### Draft Regulation

Building Act  
(chapter B-1.1)

#### Construction Code — Amendment

## Regulation to amend the Construction Code

Figure A-3.8.2.1.(2)(j)  
Stair in a dwelling unit of a residential occupancy  
Clear width".

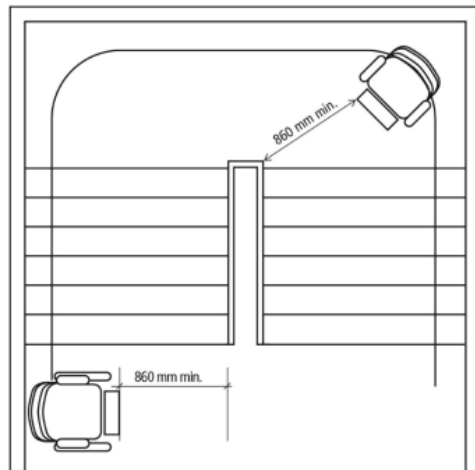
**"A-3.8.2.1.(2)(j) Barrier-Free Path of Travel.** Where all the spaces referred to in Subsection 3.8.4. or 3.8.5. are located at the entry level of the dwelling unit, the barrier-free path of travel need not extend to other levels of the dwelling unit.

It is possible to provide the spaces referred to in Subsection 3.8.4. or 3.8.5. at a level other than the entry level of the dwelling unit. The barrier-free path of travel must then extend to that other level. The installation of a ramp or a lift for persons with physical disabilities is then required.

There are several types of lifts for persons with physical disabilities and the lifting device chosen must conform to all the requirements of the Code, including the requirements of CSA B355, "Lifts for Persons with Physical Disabilities".

Where the lifting device chosen is a stair chair lift or a stair platform lift, the lifting device shall be installed when the building is constructed.

The stair must have a clear width of 860 mm in addition to the width required for the device deployed.

The width necessary for the installation and use of the device varies on the basis of the device chosen:

- for a stair chair lift, not less than 650 mm in addition to the 860 mm, that is, a stair width of not less than 1,510 mm, is to be provided;
- for a stair platform lift, not less than 1,000 mm in addition to the 860 mm, that is, a stair width of not less than 1,860 mm, is to be provided.

Figure A-3.8.4.3.-A  
Clear floor surfaces  
Door rotating on a vertical axis

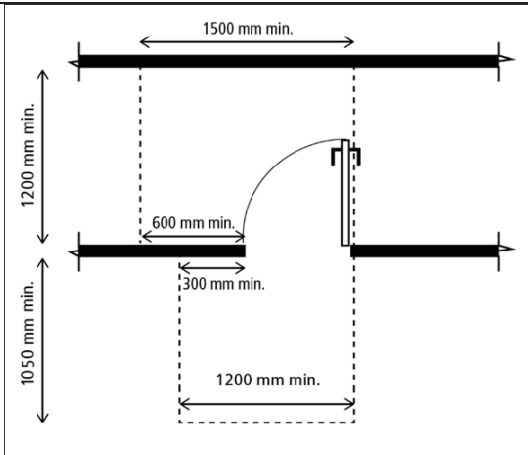
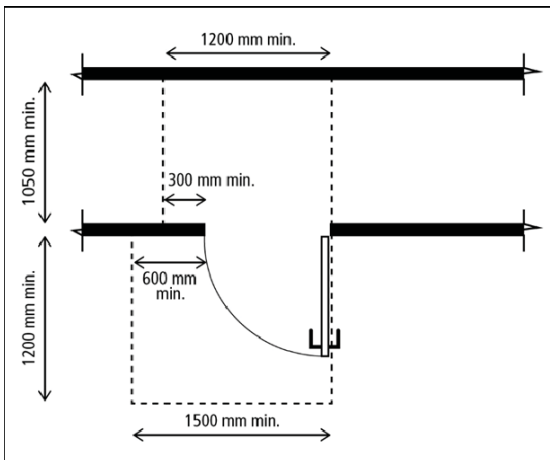
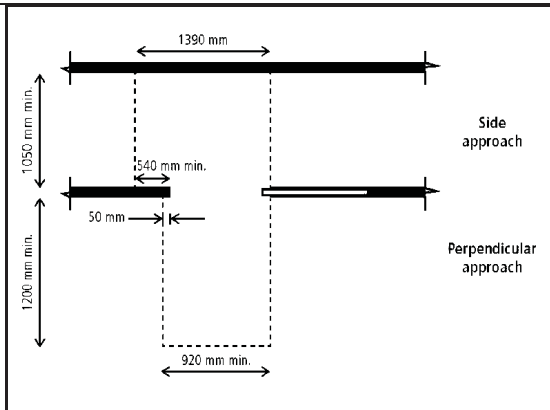
<p>Add the following notes:</p> <p><b>"A-3.8.4.2.(1)(a) Minimally Accessible Dwelling Unit.</b> In a minimally accessible dwelling unit, if the washroom is inside another space (washroom inside a bedroom) and no other washroom is accessible in the dwelling unit, the barrier-free path of travel required must extend inside the bedroom or another space to reach the washroom even if no accessibility requirement is applicable to that room.</p> <p><b>A-3.8.4.3. Doorways and Doors.</b> Clear floor surfaces on each side of the door are necessary to allow persons in wheelchairs to approach the door on the latch side, open the door and enter the room while minimizing the number of manoeuvres. The width of the clear floor surfaces on each side of the door is different depending on which side the door opens. Where the door swings toward the approach side, a dimension perpendicular to the closed door not less than 1,200 mm is required. The requirements of Article 3.8.3.3. apply to the door at the entrance to the dwelling unit. However, the requirements of Sentence 3.8.4.3.(2) do not apply.</p>

Figure A-3.8.4.5.(4)

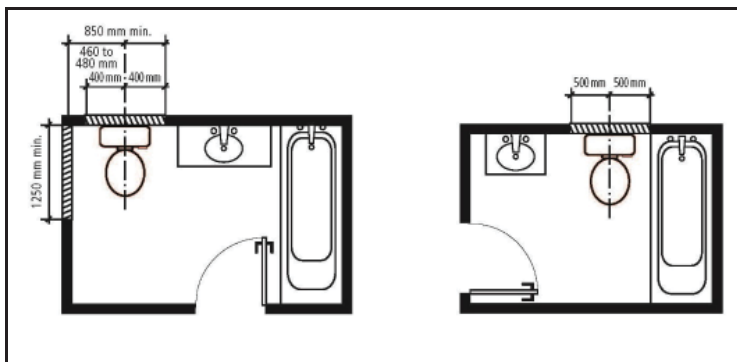
**A-3.8.4.5.(4) Washroom.** The installation of a continuous wood nailing element of 1,000 mm in width centred on the water closet is permissible where there is no wall adjacent to the water closet at a distance not more than 480 mm from the centre of the wall, allowing the installation of lateral continuous wood nailing element over a length not less than 1,250 mm. A continuous wood nailing element not less than 1,000 mm wide allows the installation of retractable grab bars on both sides of the water closet.

Figure A-3.8.5.5.(1)

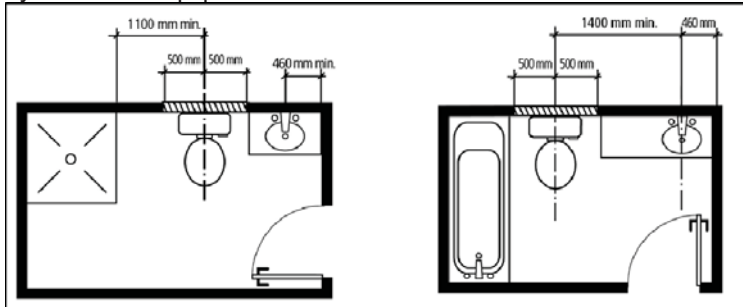
**A-3.8.5.5.(1) Bathrooms.** The lateral transfer of a person in a wheelchair to the seat of the water closet requires a clear width not less than 900 mm adjacent to the water closet and a length not less than 1,500 mm from the rear wall of the water closet. The requirement related to that surface for an adaptable bathroom allows the encroachment of a vanity or furniture for dismantling work, to meet the potential need of a person with one or more disabilities occupying the dwelling unit. However, encroachment of that space by bathroom equipment such as the shower or the bathtub is not permissible.

Figure A-3.8.5.5.(2)

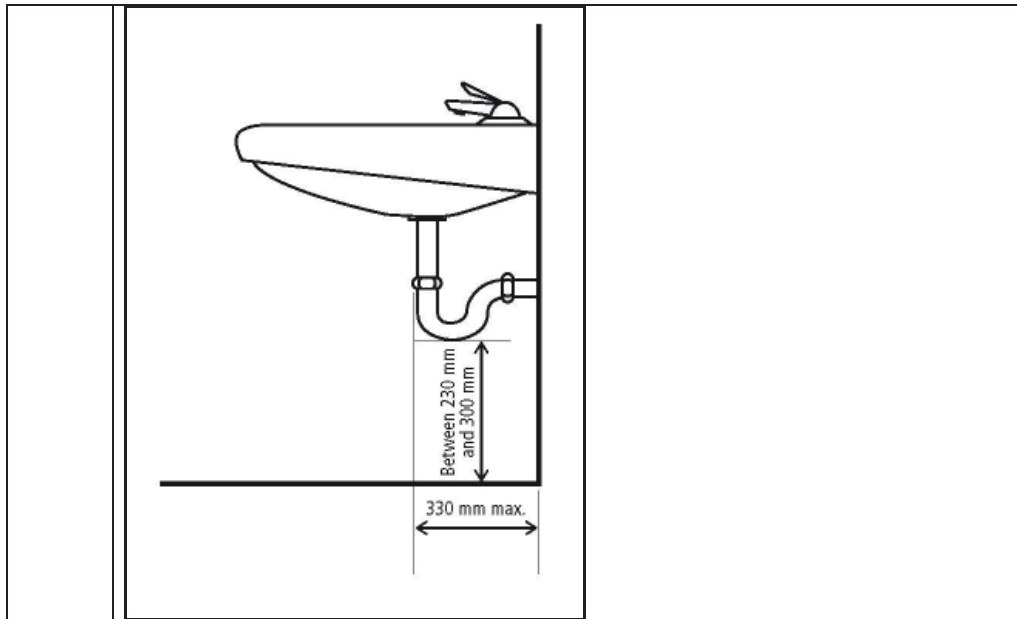
**A-3.8.5.5.(2) Bathroom.** To allow persons in wheelchairs front access to the lavatory, the clear height under the trap must be not less than 230 mm. In addition, to allow those persons to use the lavatory, the lavatory will have to be lowered to a height not more than 865 mm. For that purpose, the distance measured from the floor to the bottom of the trap must be not more than 300 mm.

In an adaptable dwelling unit, the edge of the lavatory need not be installed at a height not more than 865 mm in relation to the floor or to allow front access to the lavatory of the bathroom. However, an appropriate installation of the plumbing is required to allow future adaptation.

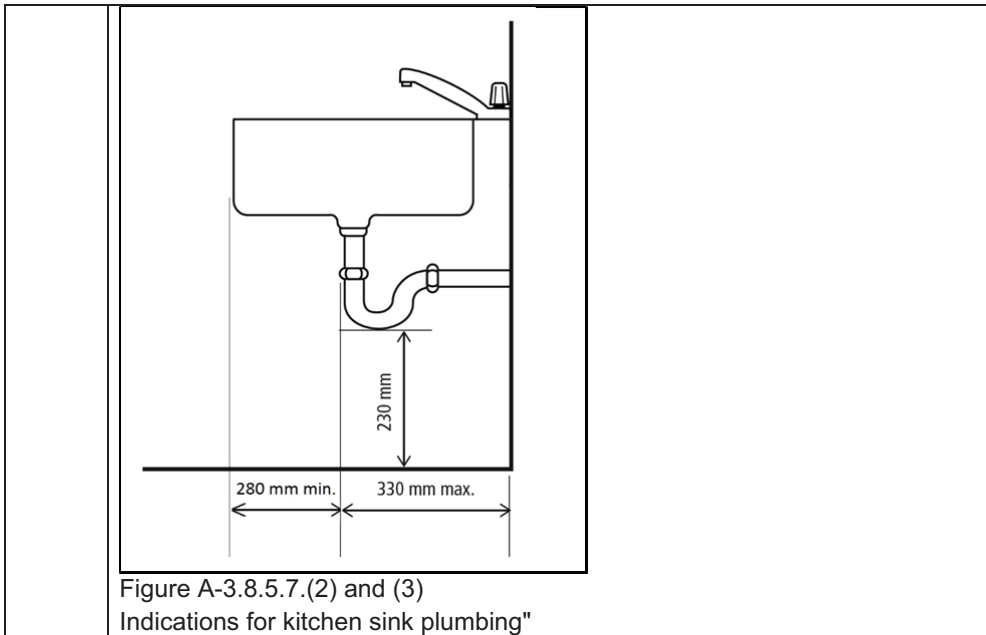
**A-3.8.5.7.(2) and (3) Kitchen Sink Plumbing.** To allow front access to the sink by a person in a wheelchair and a sink height not more than 865 mm, the height measured from the floor to the bottom of the sink trap must be 230 mm.

In the case of a sink installed in a kitchen island, the longitudinal dimension to give persons in wheelchairs front access to the kitchen sink may be measured from the front edge of the counter of the island containing the sink and must be not less than 280 mm.

In an adaptable dwelling unit, counters need not be installed at 865 mm and kitchen furniture is allowed under the sink. However, an appropriate installation of the plumbing is required to allow future adaptation.
